Product Change Notice (PCN)

PCN Number: PCN-0451561R-01

Product(s) Affected: SJ-3551B-MSMT-TR-67, SJ-3552B-MSMT-TR-67

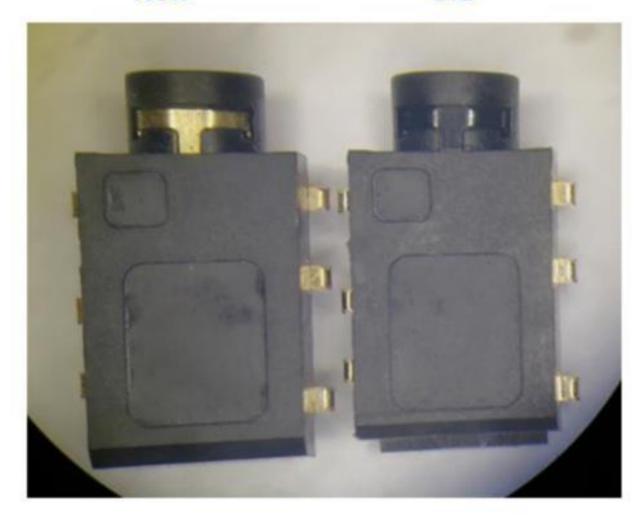
Description of Change: Ground contact changing from Black Nickel to Gold Flash plating. Photos of changes included below.
